## Building C

Revised Scheme -  
C1 Second Floor /  
C2 First Floor

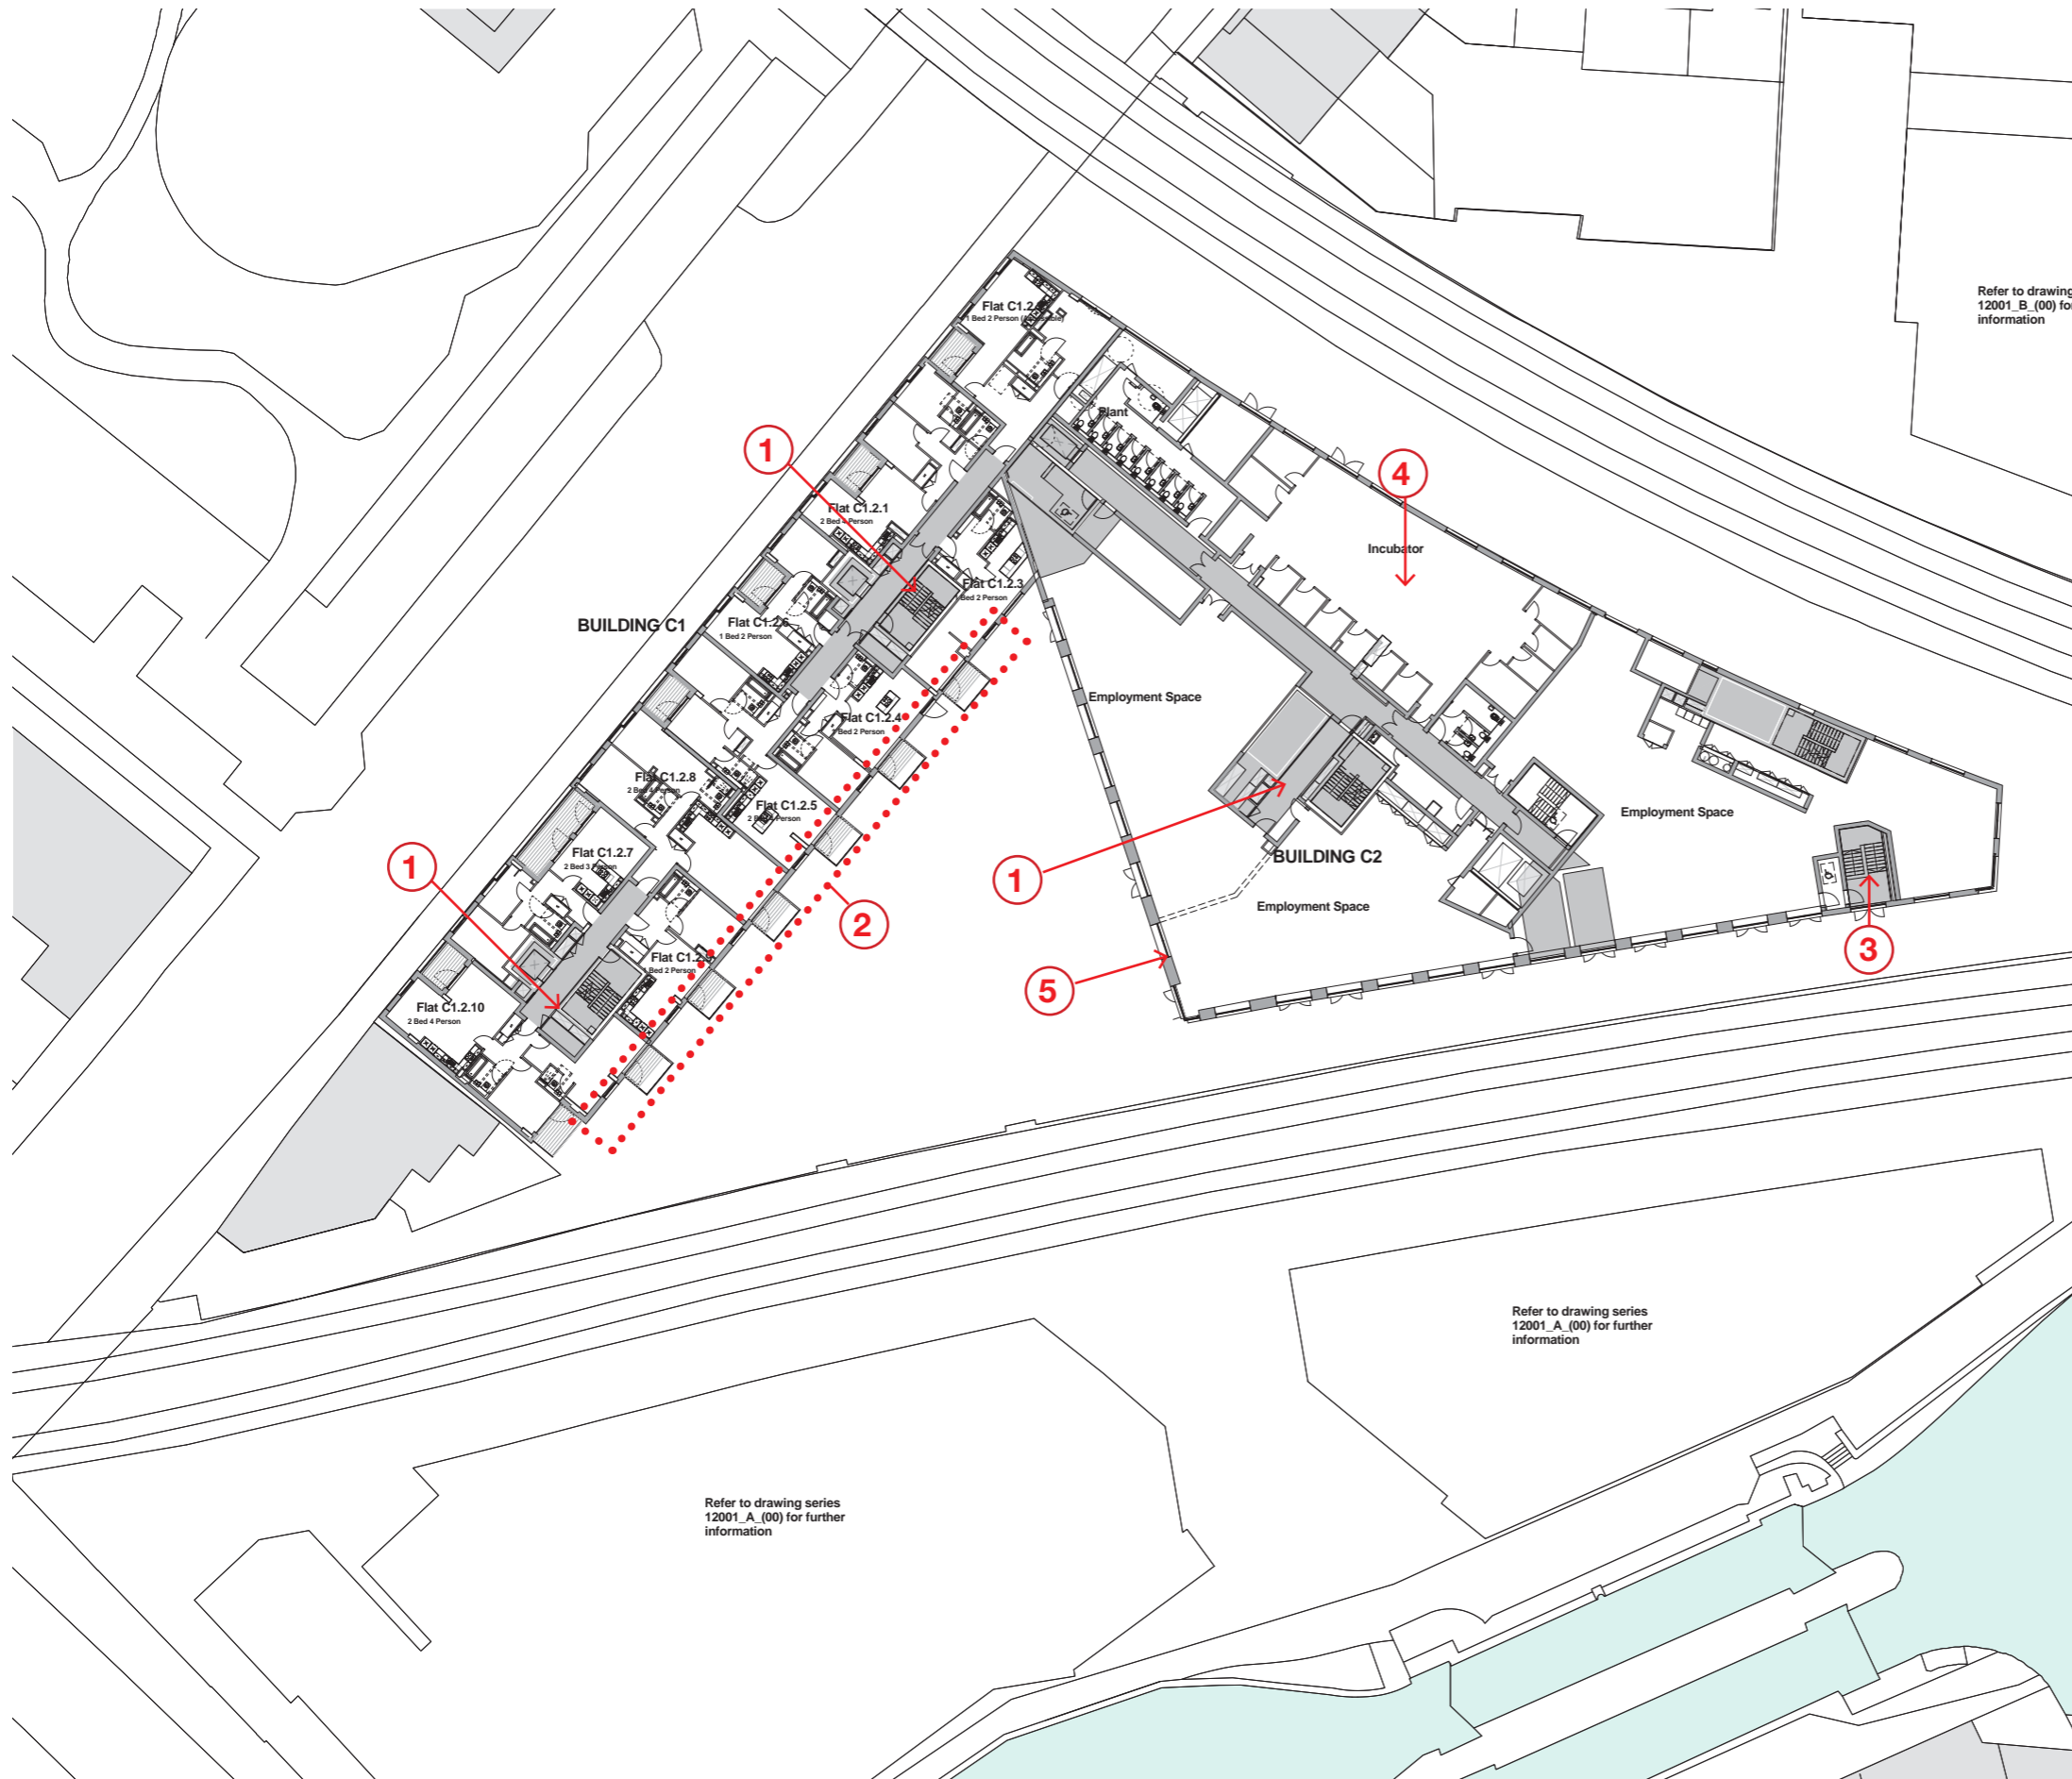
- ① Core layout revised to meet vertical transportation strategy
- ② Balcony locations rationalised to improve design & efficiency
- ③ Additional escape stair for office required as per fire strategy
- ④ Detailed design for incubator space revised as per planning condition
- ⑤ Additional window added to employment space to improve daylighting and to rationalise facade setting

## 4.20 Revised Scheme - C1 Third Floor / C2 Second Floor

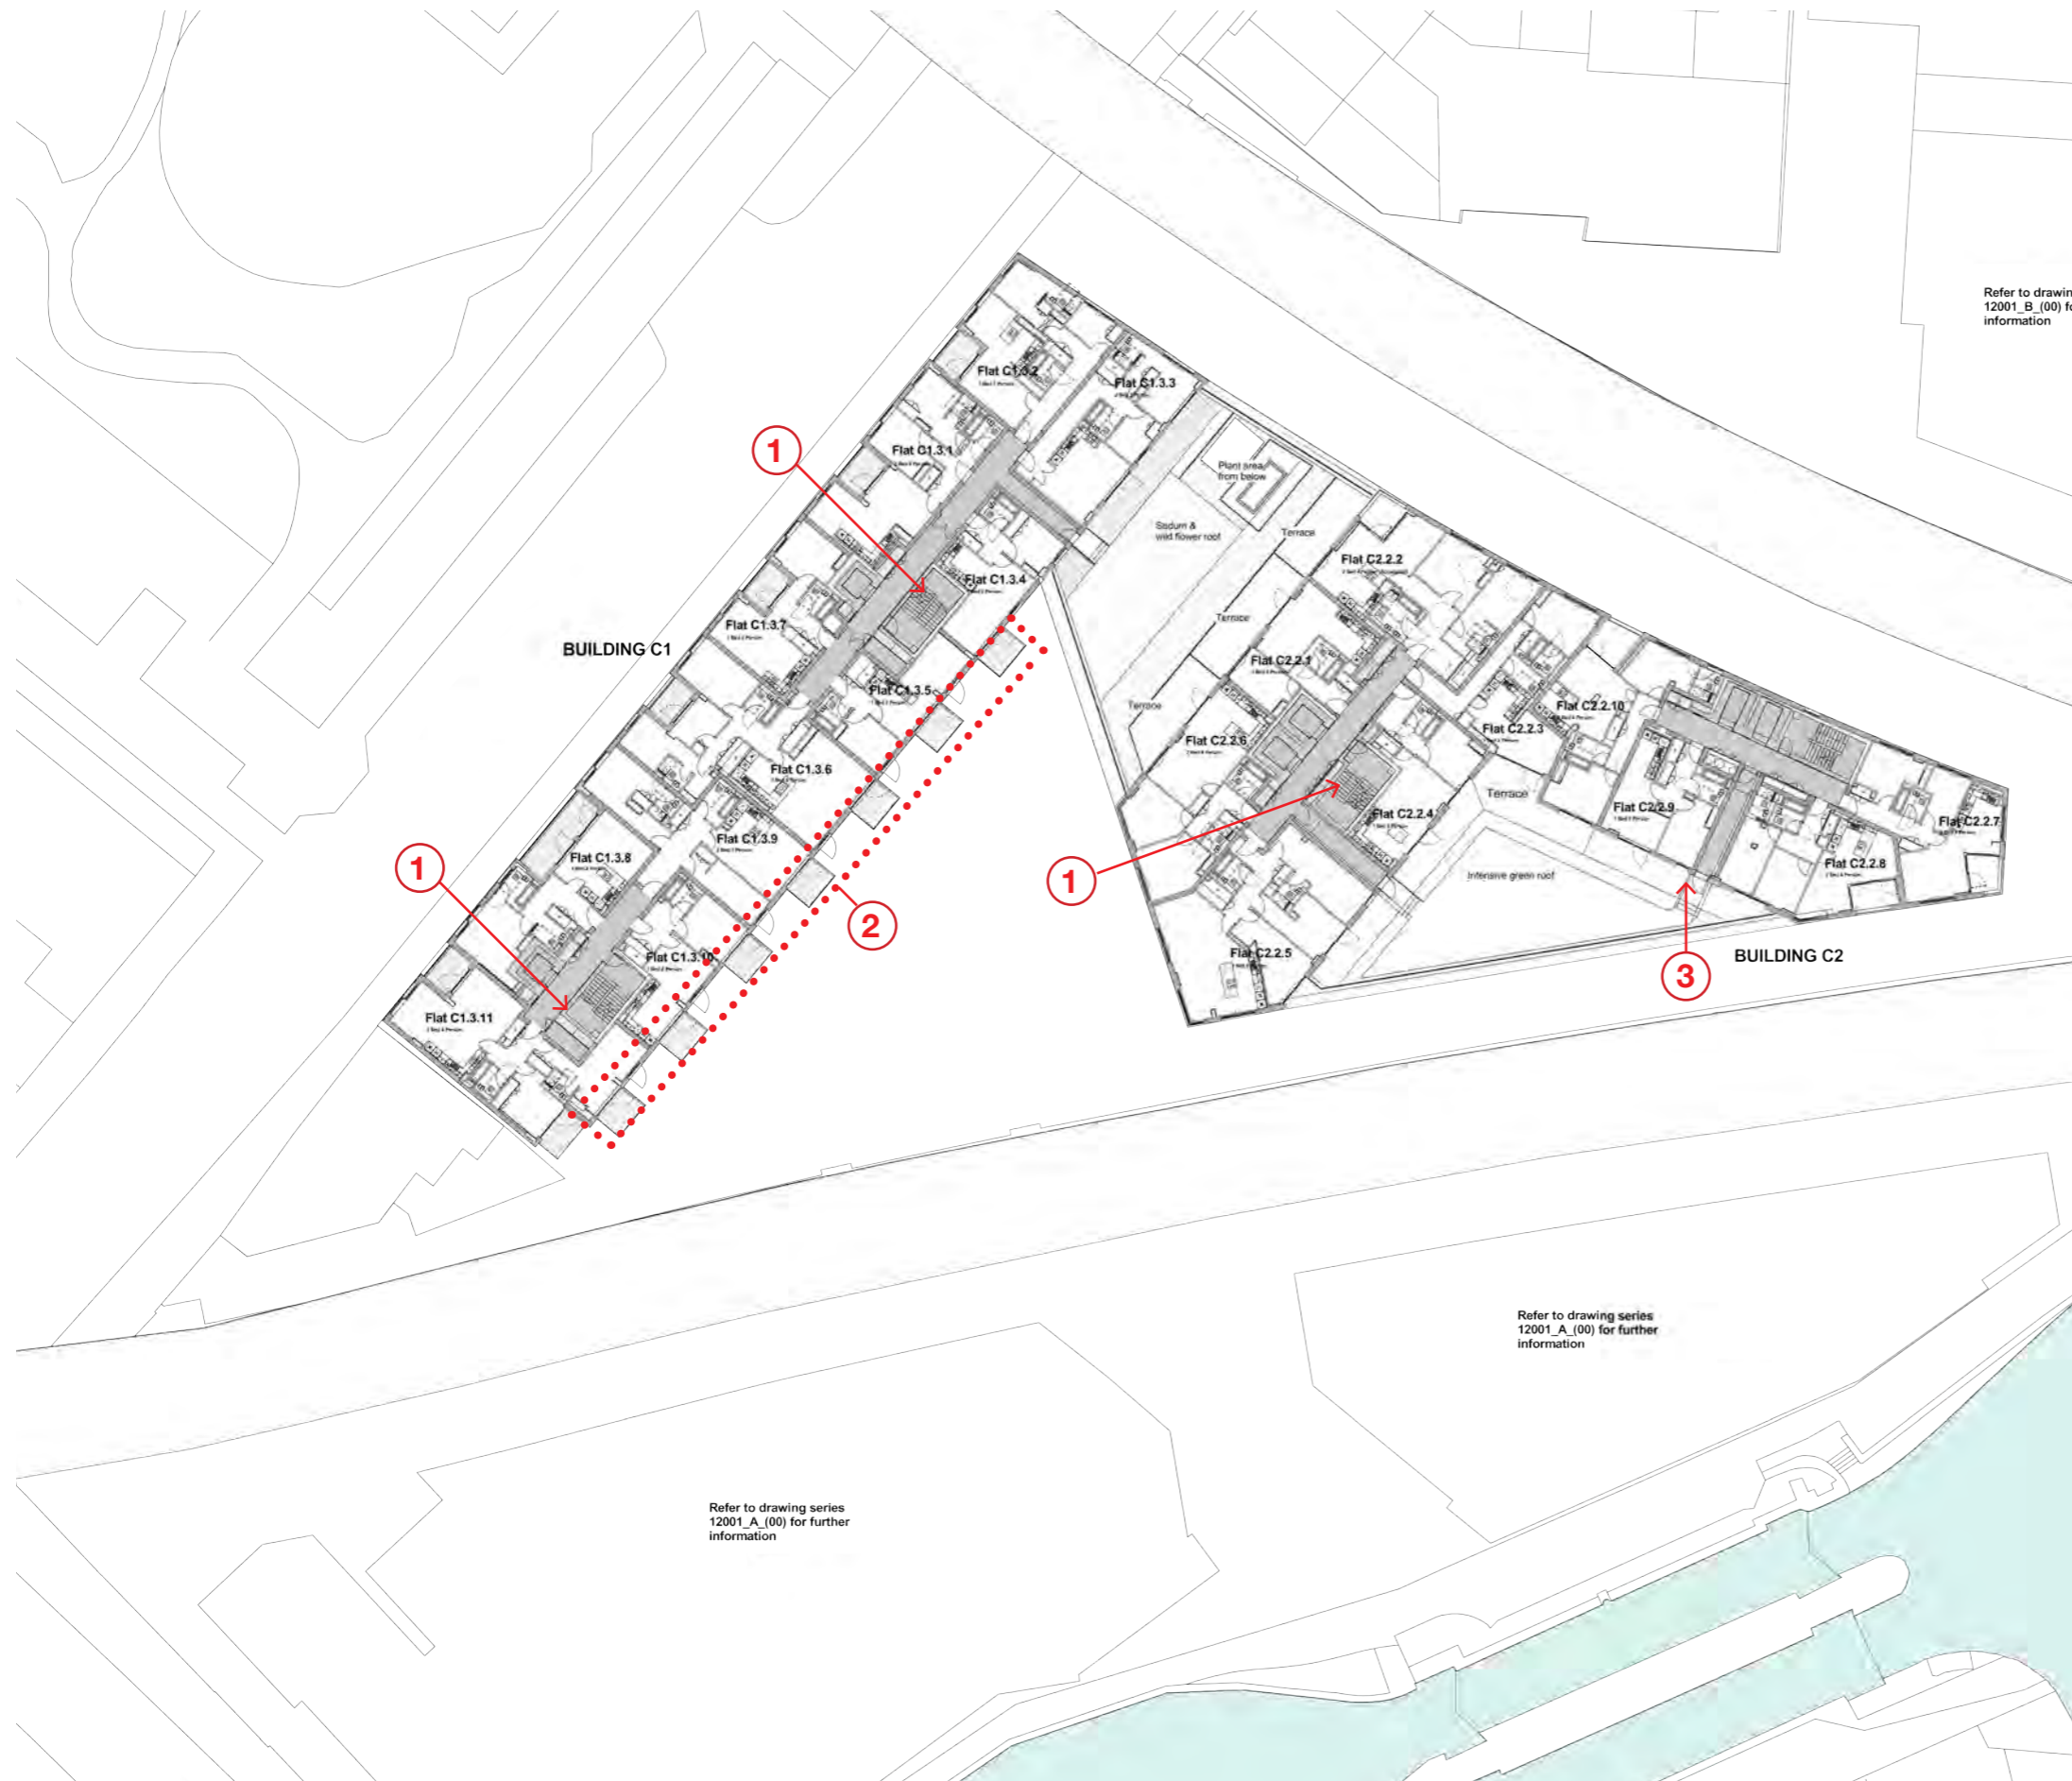
- ① Core layout revised to meet vertical transportation strategy
- ② Balcony locations rationalised to improve design & efficiency
- ③ Additional emergency access doors required to roof terrace

### Revised Scheme - C1 Fourth Floor / C2 Third Floor

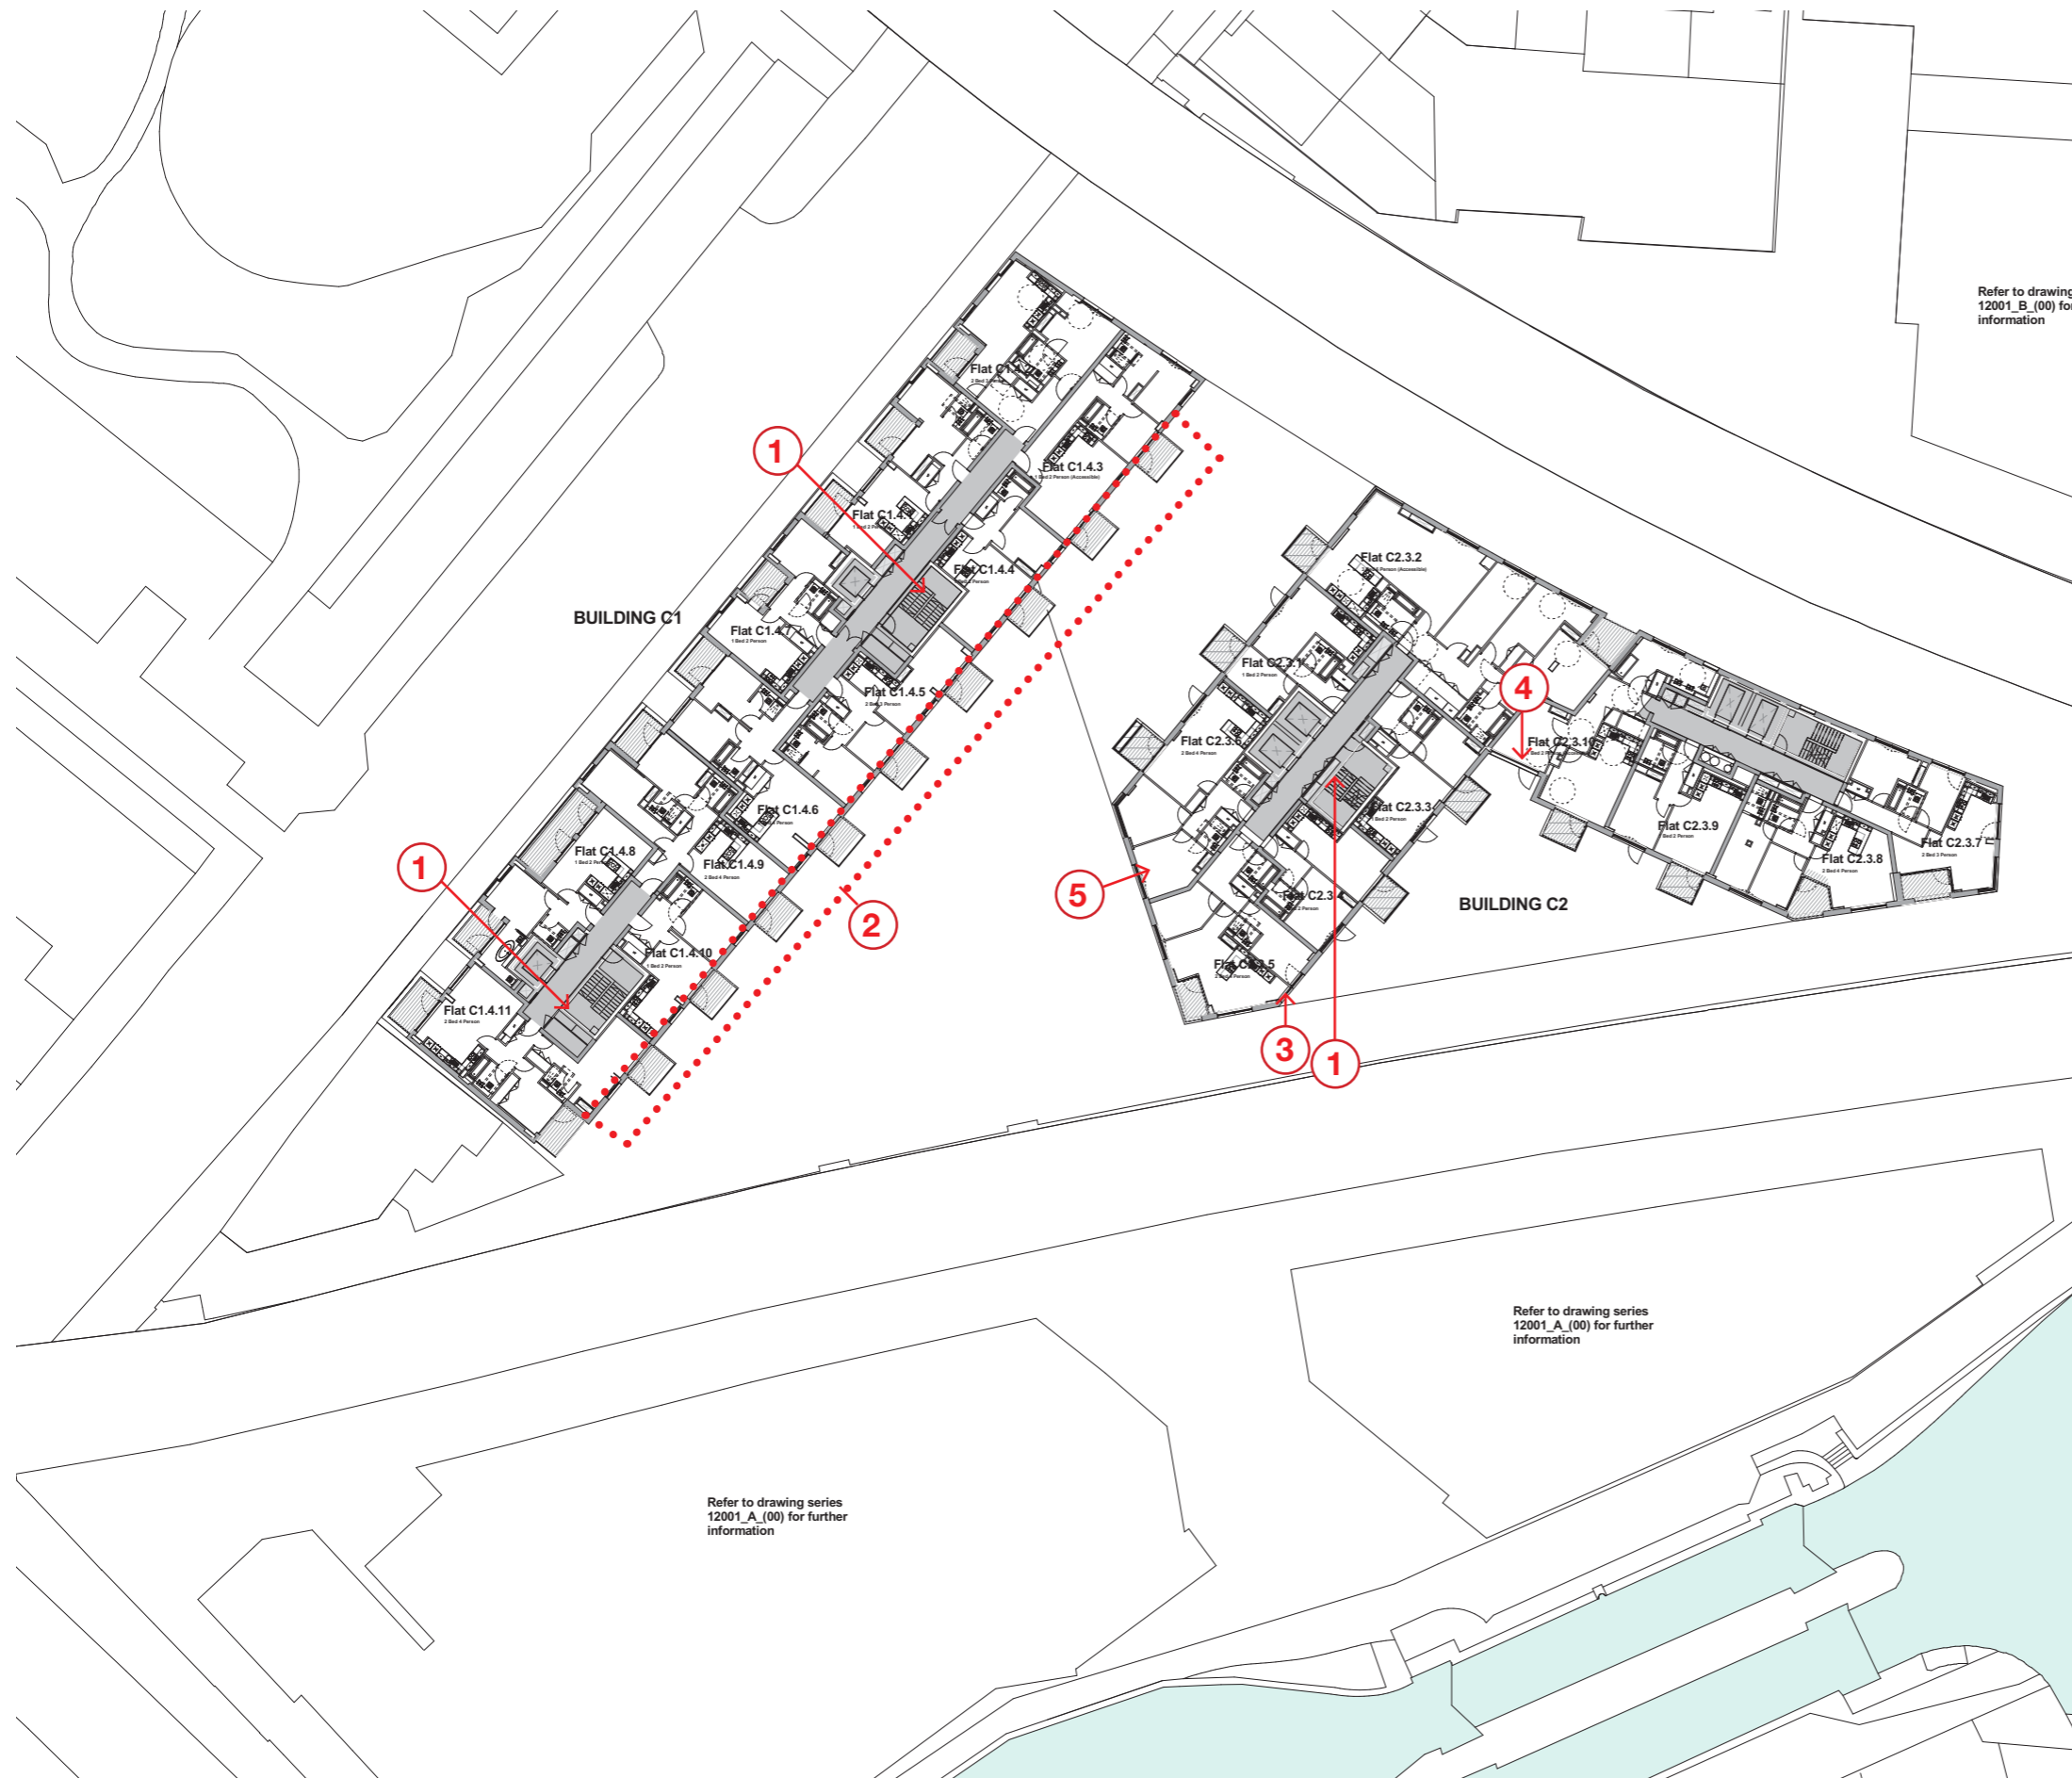
- ① Core layout revised to meet vertical transportation strategy
- ② Balcony locations rationalised to improve design & efficiency
- ③ Window amended as per daylight & sunlight strategy
- ④ Balcony removed due to privacy concerns
- ⑤ Inset balcony removed in order to rationalise facade setting
